PREVOST

WARRANTY BULLETIN

WB23-40

SUBJECT: **JUMPER ON CONNECTOR A175**

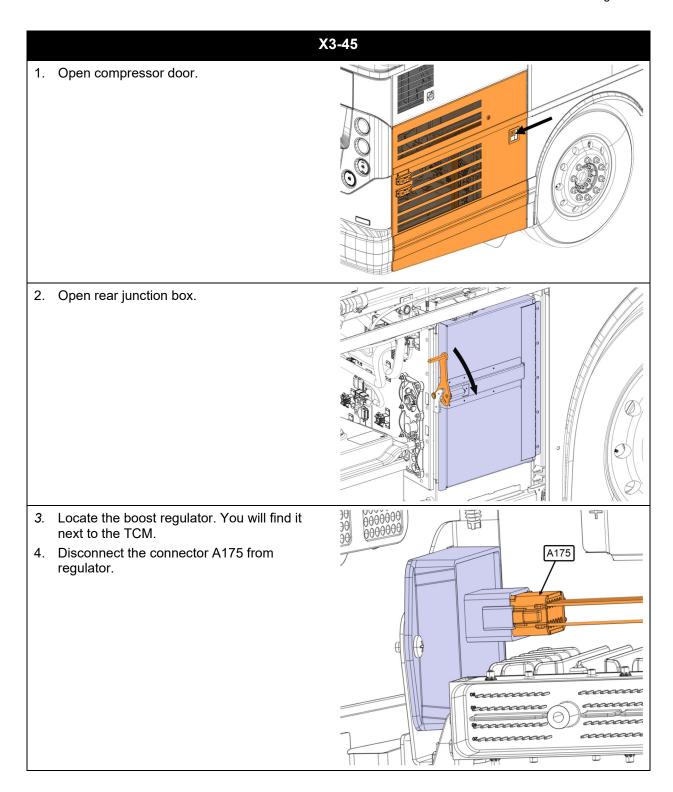
5. Connect jumper connector 0610187 to the harness, connector A175.
